**IEEE P802.19**  
**Wireless Coexistence**

**Comment Resolution on CID#68**

Date: 2012-05-14

This document provides normative text related to a the CID#68 for clarification on the timing of process a CE initiation and termination.

**Figure 4— Reference model of a CE**

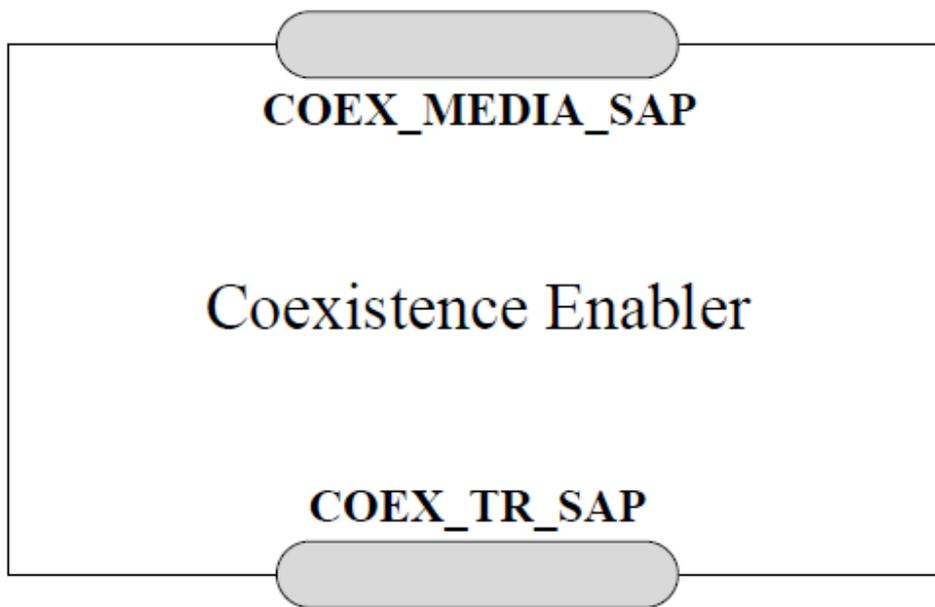
CID	Clause	Subclause	Page	Line	Type	Comment	Suggested Remedy	Response
68		5.2.1.1				I guess a CE is a kind of s/w agent entity. Specifically it would be a sort of process which handles TCP/IP packets. Under what condition, how the process should be started on? Moreover, how the process goes to be terminated?	need clarification.

The reference model of a CE is shown in Figure 4. CE, as a client or agent process, can be initiated by a user. After then the CE shall try to discover CMs around it for doing authentication procedure. The CE can be terminated by a user at any time, and it shall be terminated when it has no session with any CM for a while.
